July 5, 2018

Project No. 1668958

**ADDENDUM NO. 1 – GEOTECHNICAL INVESTIGATION
CITY PARK RESIDENTIAL – PHASE 2
OTTAWA (FORMER GLOUCESTER), ONTARIO**

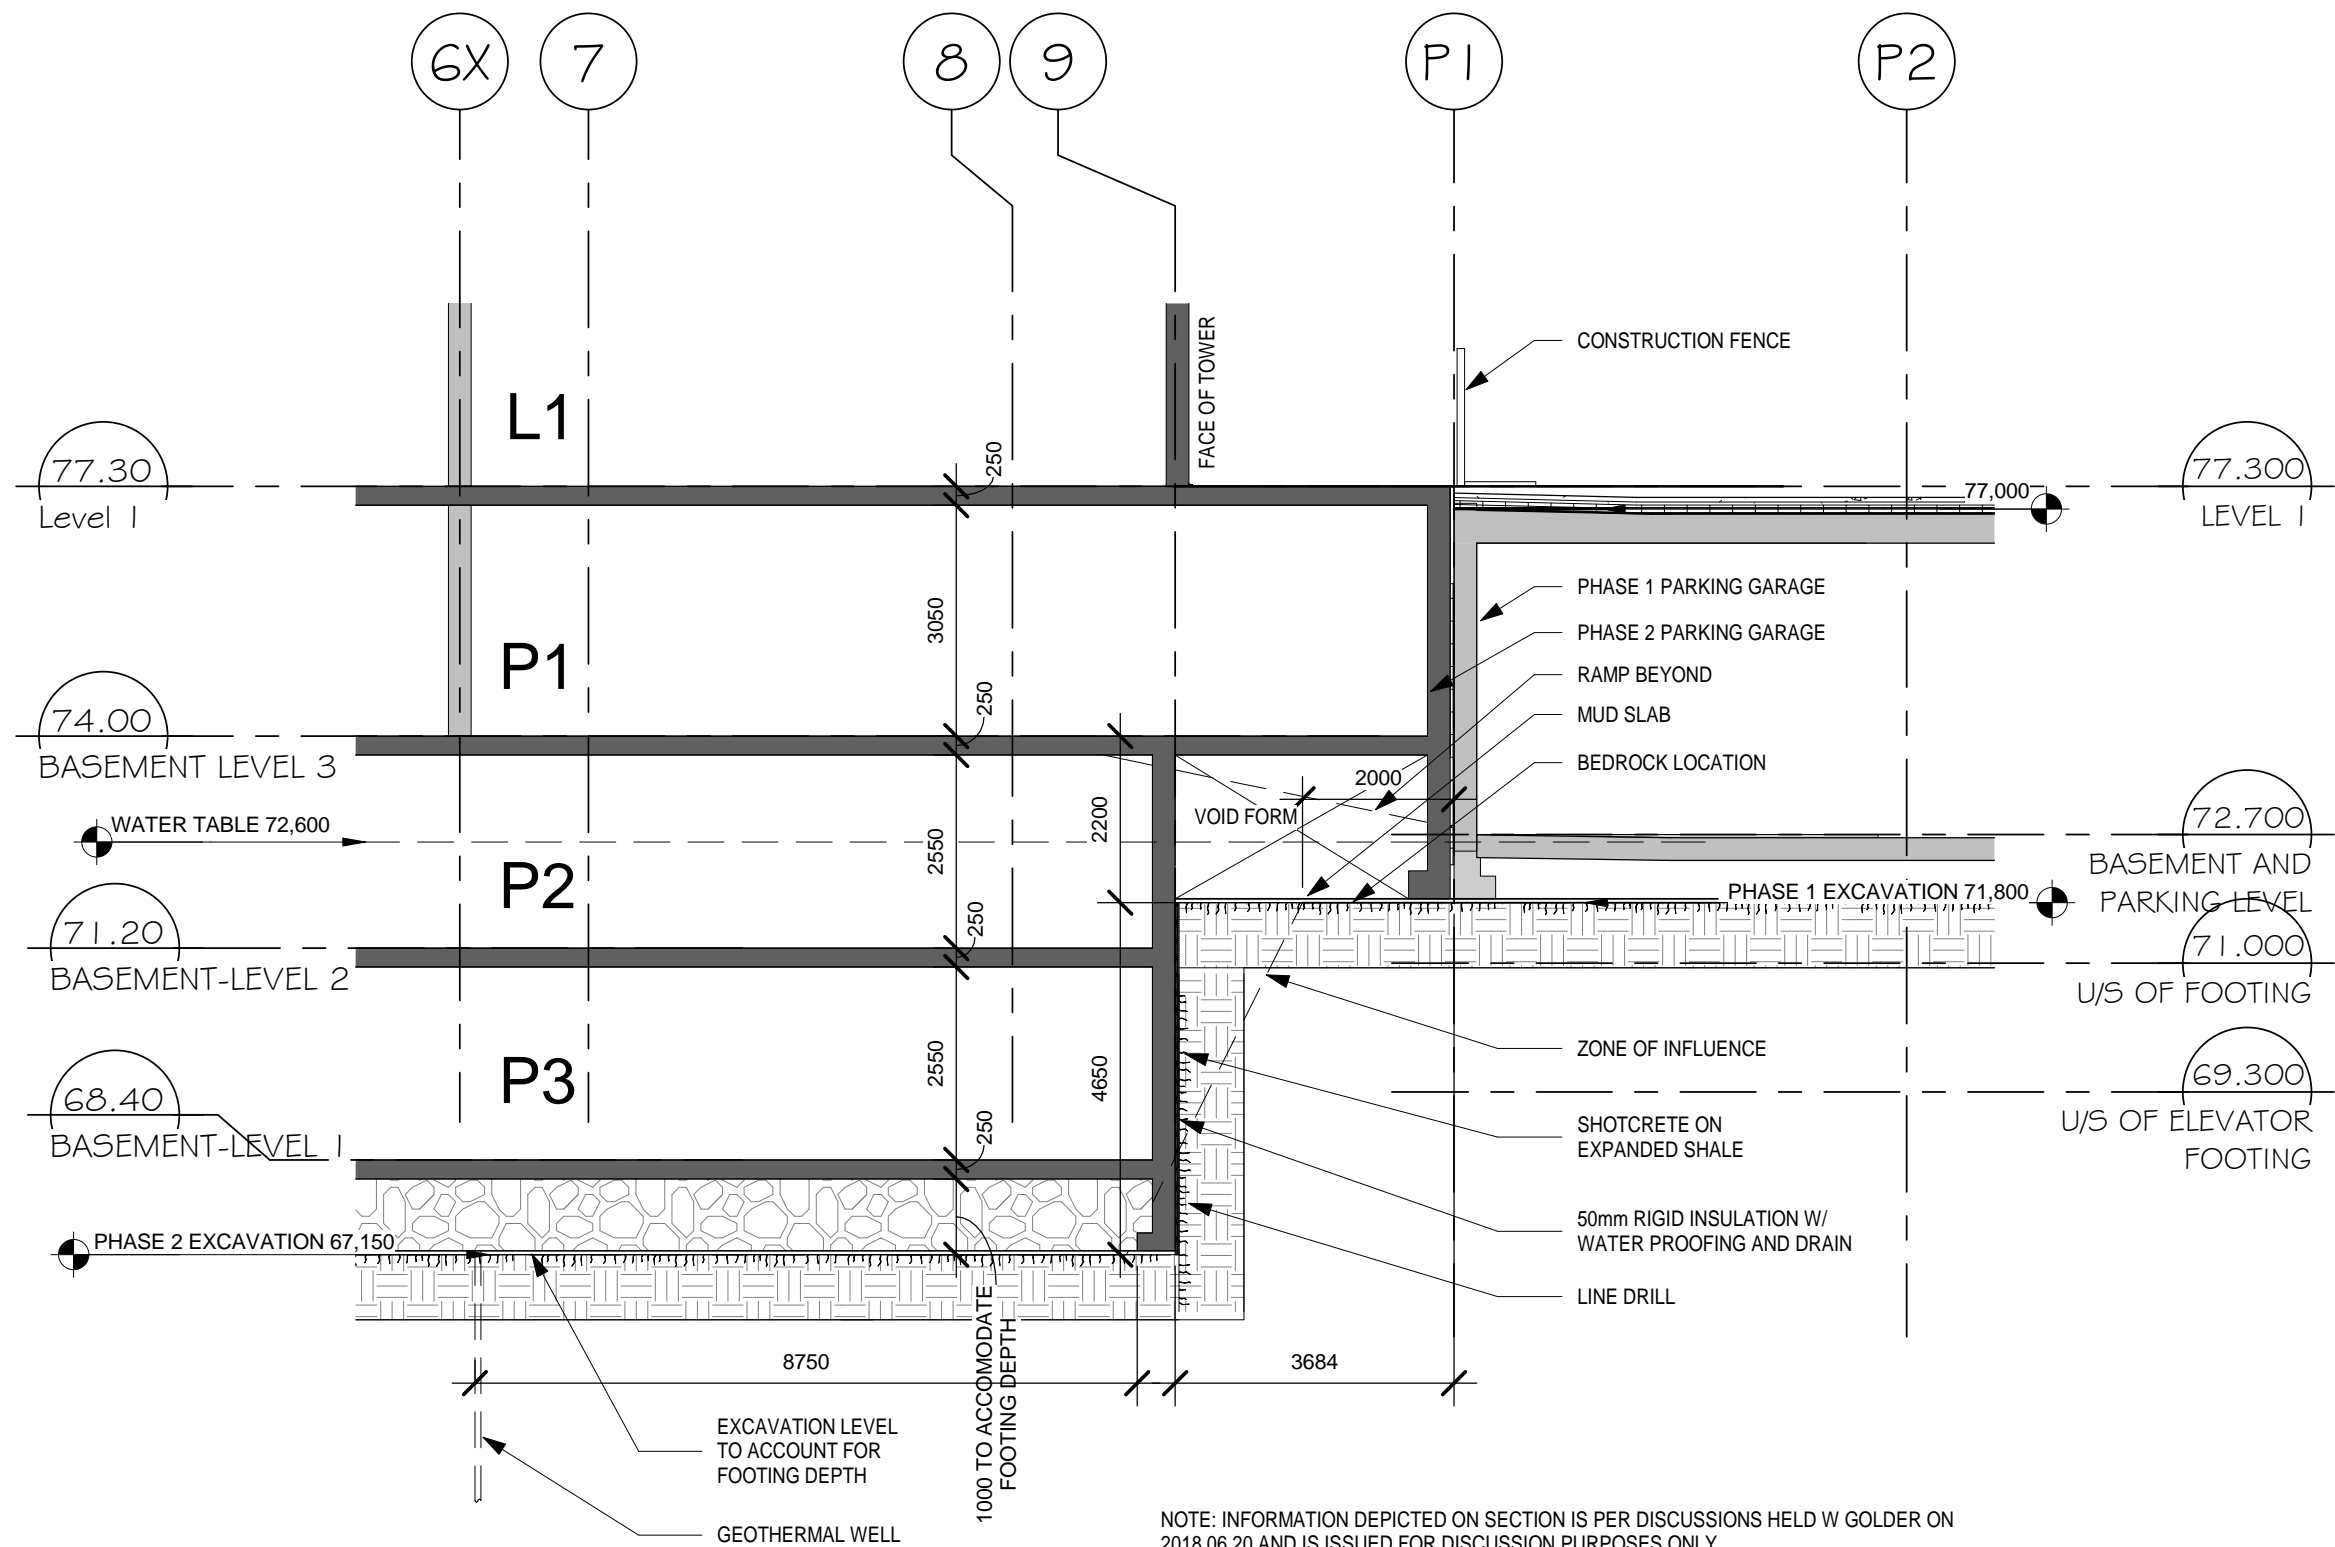
As shown on the attached drawing (SKA-001), on the east side of the Phase 2 Tower, the foundation wall of the structure will abut the foundation wall of the existing Phase 1 Tower (which was constructed in 2017) to about elevation 71.8 metres. Below that elevation, the Phase 2 Tower foundation wall will extend to the base of excavation (67.2 metres) and will abut the excavated bedrock face.

Where the Phase 2 tower excavation will abut the Phase 1 tower foundations, the crest of the near vertical bedrock excavation should be set back at least 3.5 metres from the edge of the footings at the higher elevation level. Although the remaining ledge of bedrock will be protected with a mud slab and shotcrete, it is possible that some air exposure near the crest of the bedrock ledge will occur as a result of the limited groundwater drawdown in proximity to the Phase 2 excavation. Therefore, any link between the Phase 1 tower basement and the Phase 2 tower basement should consist of a structural slab placed on a void form at least 300 millimetres in thickness to mitigate the risk of floor slab heaving as a result of the swelling shale (as is currently shown on the attached drawing SKA-001).

Wherever the foundation walls will be in contact with the bedrock, the excavated rock face should be covered with at least 50 millimetres thick of compressible rigid insulation, along with waterproofing and a drainage system, and the concrete for the foundation walls should also contain sulfate resistant concrete (Type HS or HSb cement). In order to keep the shale bedrock wet and minimize the levels of air exposure, the waterproofing membrane should be placed onto the insulation layer first, followed by the drainage system and then the foundation walls. The waterproofing membrane should be extended along the entire height of the bedrock face, and along the floor of the excavation for a distance of at least 3 metres from the sides of the excavation.

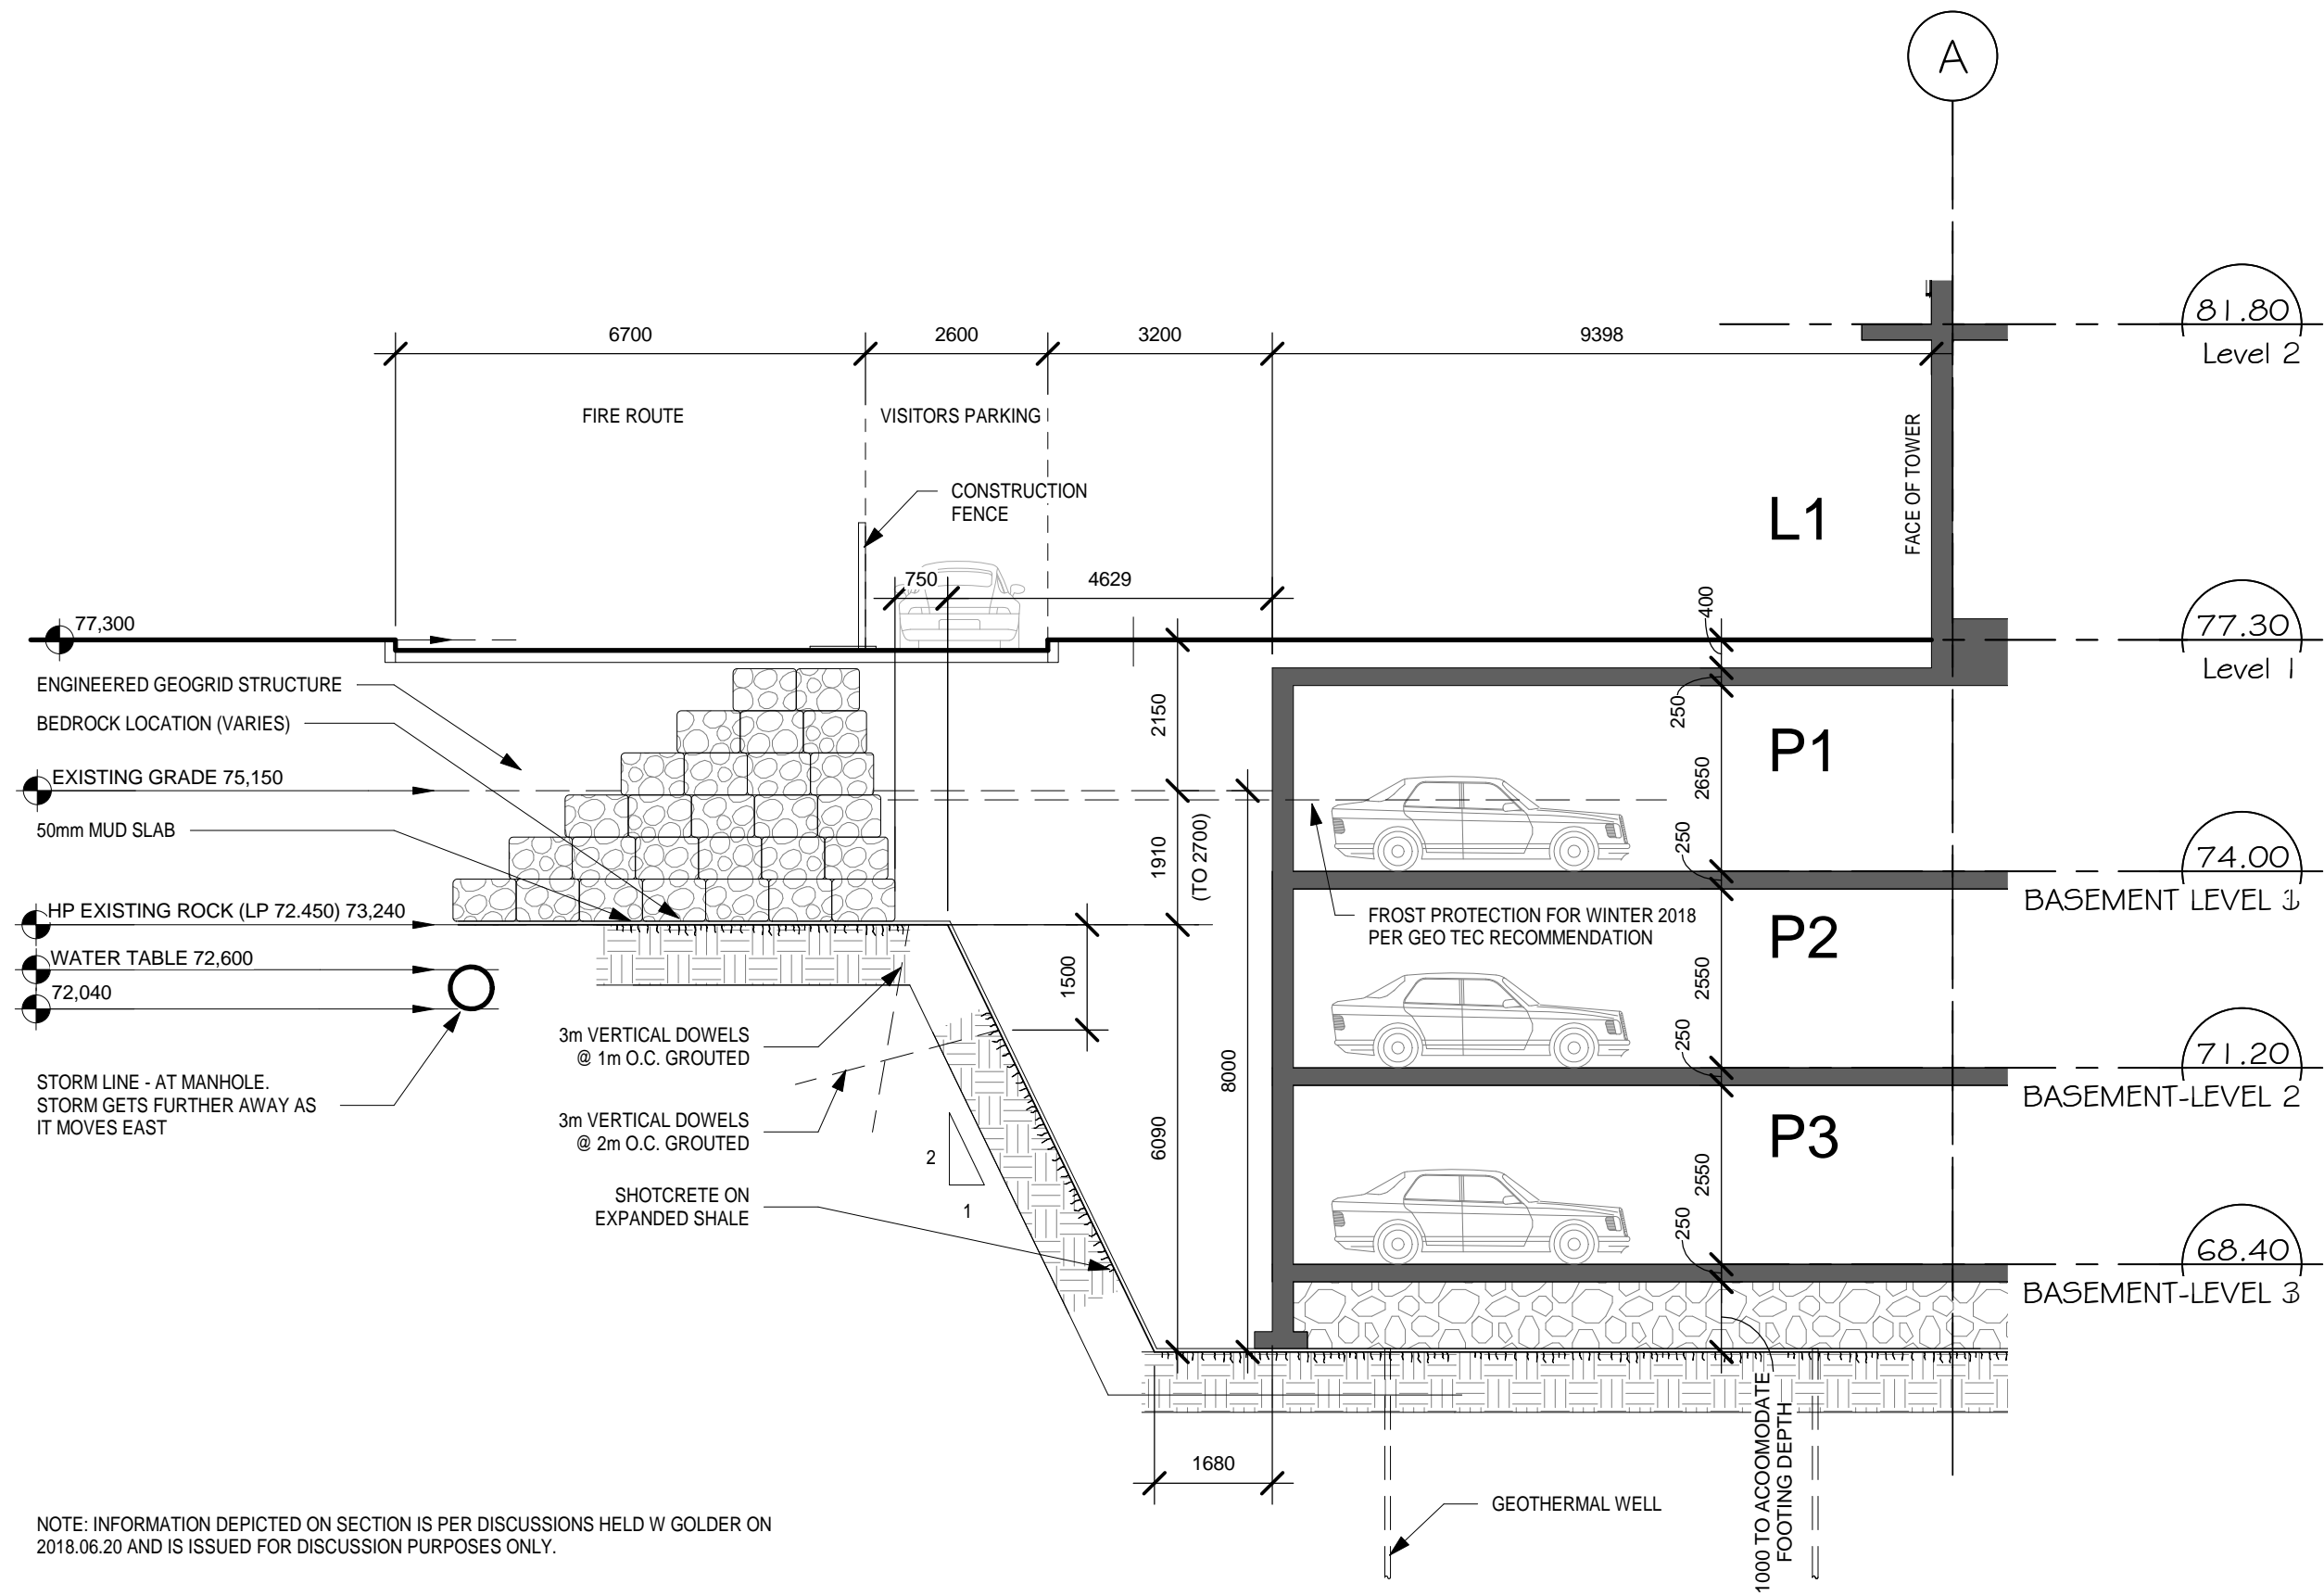
Also shown on the attached drawing (SKA-002), due to the limited space on the north side of the Phase 2 Tower, a temporary retaining structure will be required in this area to support the front main drive isle during construction excavation.

As previously noted, a temporary retaining structure will be required to support the front main drive isle (north side of the tower) during construction excavation. The lateral earth pressures acting on the retaining structure will depend on the type and method of placement of the backfill, the nature of the soils behind the backfill, the magnitude of surcharge including construction loadings, the freedom of lateral movement of the structure, and the drainage conditions behind the walls.

The above rock stabilization measures should be carried out prior to the construction of the retaining structure on the north side, and prior to allowing any construction traffic within 4 metres from the crest. Where heavier than standard construction loading will be imposed near the crest of the rock slopes, such as large cranes, an additional set back from the crest of at least 2.5 metres is required in addition to the stabilization measured listed above.

It is also recommended that drainage be provided at the toe, behind the retaining structure to prevent hydrostatic pressure from building up behind the temporary retaining structure.
